In support of the Desert Quartzite Solar Project, Variance 03 (VAR-03) (See **Attachment B** for location).

Desert Quartzite Solar Project, Variance 3

O&M SITE PLAN EXHIBIT

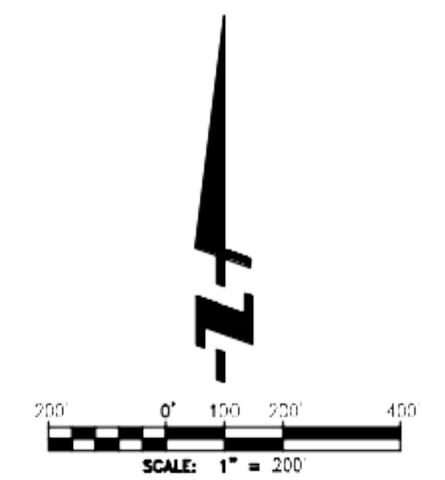
Variance Justification:
 The proposed variance involves an adjustment to the location of the operations and maintenance (O&M) building within the approved project site. The proposed location of the O&M building is 400 feet to the north of the approved location. The variance is being requested to locate the O&M building closer to the onsite power source.
 See Attachment A for the Purpose and Need
 See Attachment B for a map of the approved and proposed O&M building location.

The Proposed Action, and subject of Variance Request 3, would relocate the O&M building 400 feet to the north of the location approved in the ROW Grant.
